BECO 88-126
 August 18, 1988

REVISED INFORMATION REGARDING PILGRIM STATION
SAFETY ENHANCEMENT PROGRAM

Attachment: Section 3.2 Revision 1 "Installation Of A Direct Torus Vent System (DTVS)"

FIGURE 3.2-1

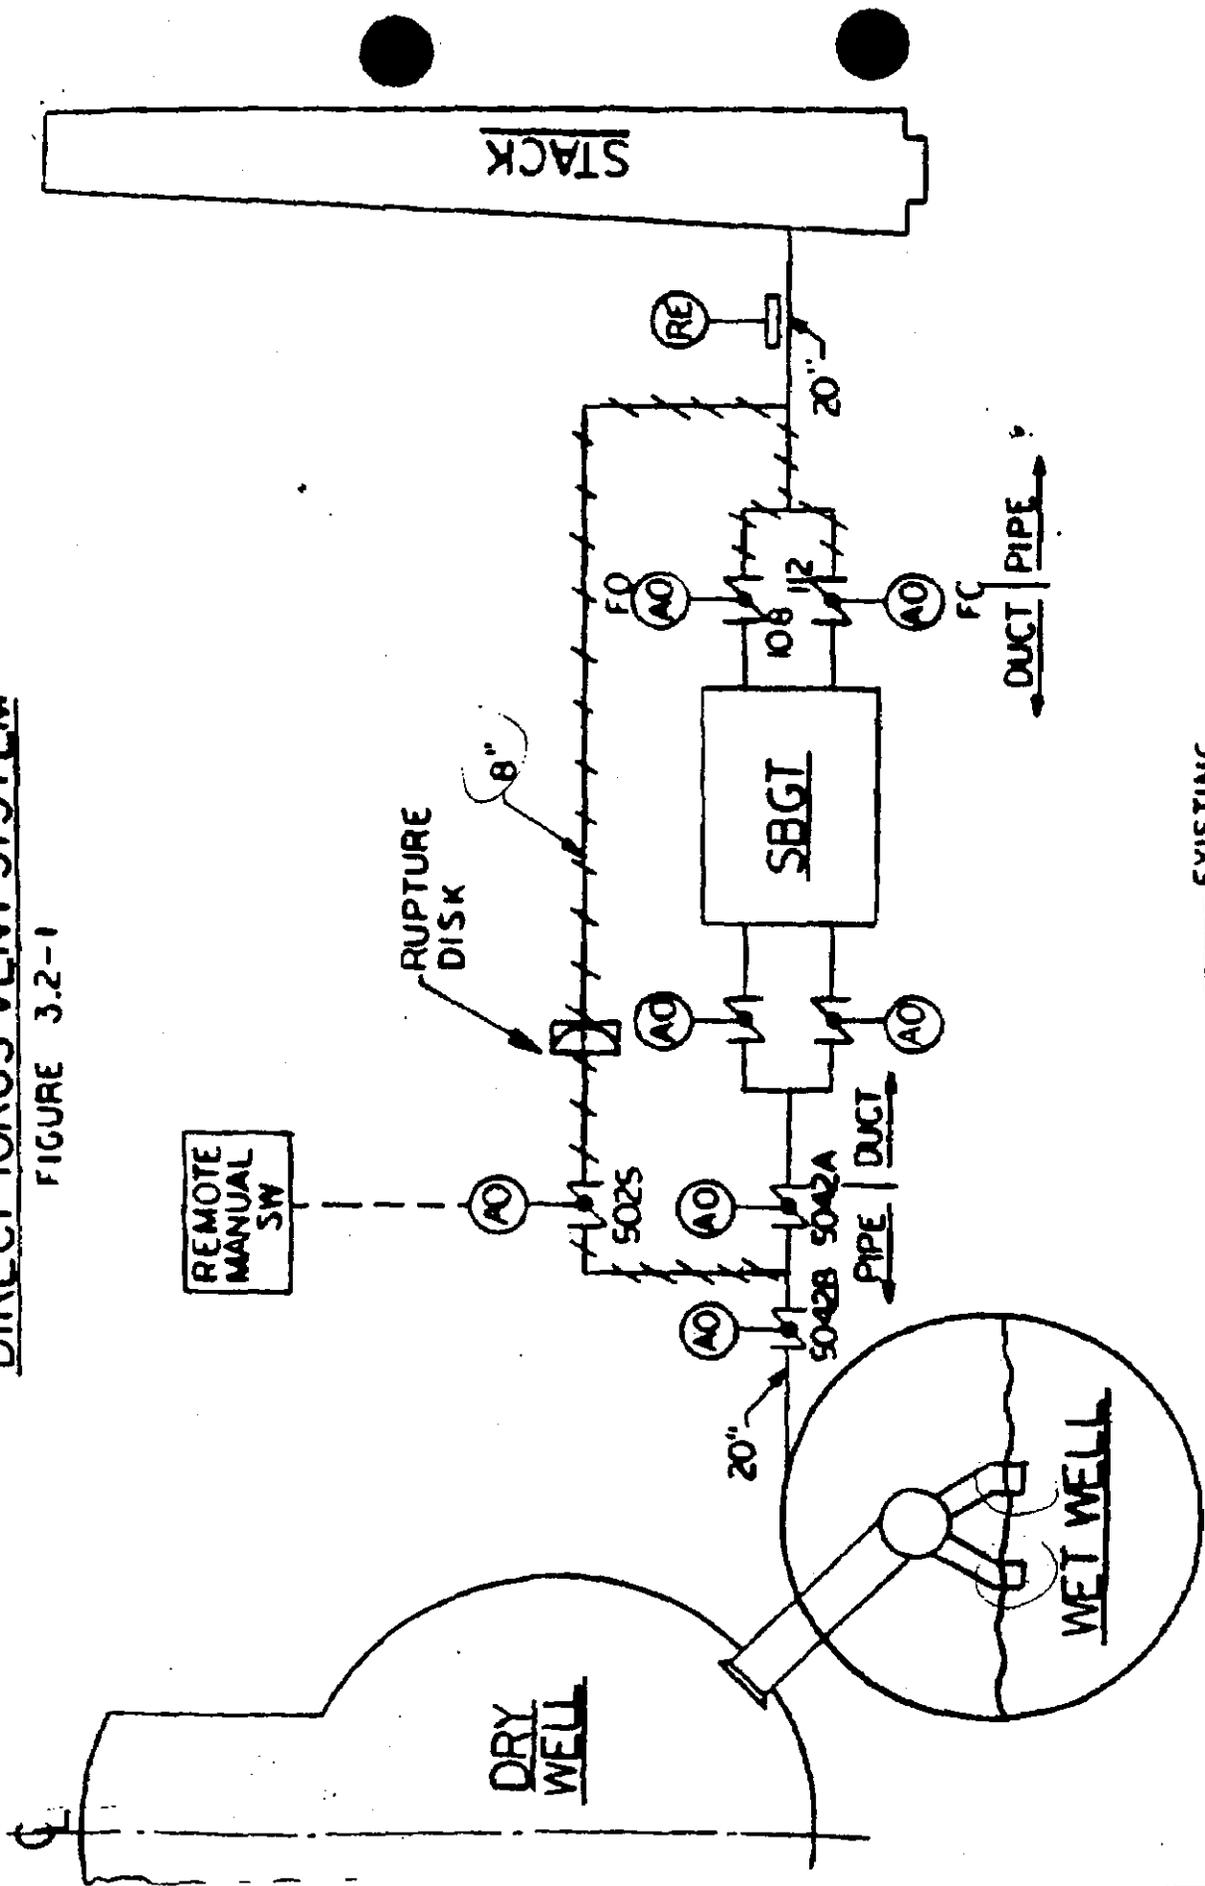
Enclosed is a description of a revised design for the Direct Torus Vent System (DTVS) that was described in the "Report on Pilgrim Station Safety Enhancements" dated July 1, 1987 and transmitted to the NRC with Mr. Bird's letter (BECO 87-111) to Mr. Varga dated July 8, 1987. This revision supersedes in its entirety the Section 3.2 included in the July 1, 1987 report.

As you are aware from plant inspections we have installed the DTVS piping and portions of related control wiring. Currently, the DTVS is isolated from the Standby Gas Treatment System (SBGTS) by blind flanges installed in place of Valve AO-5025 and the DTVS rupture disk. This configuration was inspected by NRR in the performance of a technical review which focused on System, Mechanical Design and Structural Design issues. The review took place on March 2-3, 1988 as documented in NRC Inspection Report #88-07, dated May 6, 1988 and determined the installation configuration to be acceptable. We now plan to remove these blind flanges and proceed with installation of Valve AO-5025 and the DTVS rupture disk. We conclude the valve and rupture disk provide equivalent physical isolation of the DTVS piping from the SBGTS and appropriately ensure the operational integrity of the SBGTS under design basis accident conditions. Following completion of this work, we will perform a local leak rate test to verify that Valve AO-5025 is acceptably leak tight using the same method previously utilized in testing the blind flange. We also plan to complete all remaining electrical work on the DTVS in accordance with the revised design.

On the basis of the revised Section 3.2, we conclude that the DTVS design as described in the enclosure does not require any change to the Technical Specifications and that we can proceed with installation without prior NRC approval.
